Technical Service Information

FORD AOD NO 4TH GEAR

Figure 1

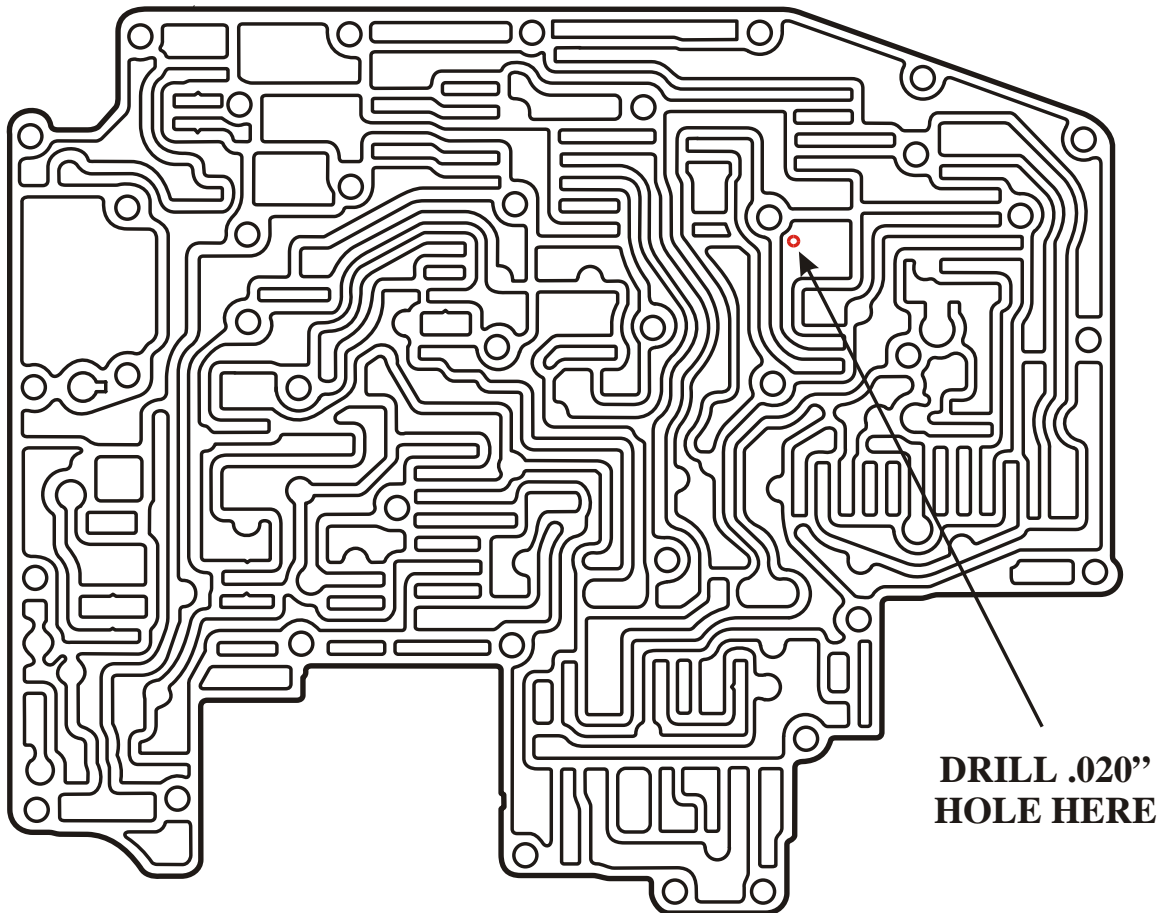
COMPLAINT: Very late 4th gear, or NO 4th gear.

CAUSE: Valve Body and/or Case cross leaks.

CORRECTION: Drill a vent hole through valve body casting, in the 3-4 T.V. modulator circuit, using a .020" drill bit. See Figure 1 for the location. The smaller drill bits can usually be obtained at the local hobby shop.
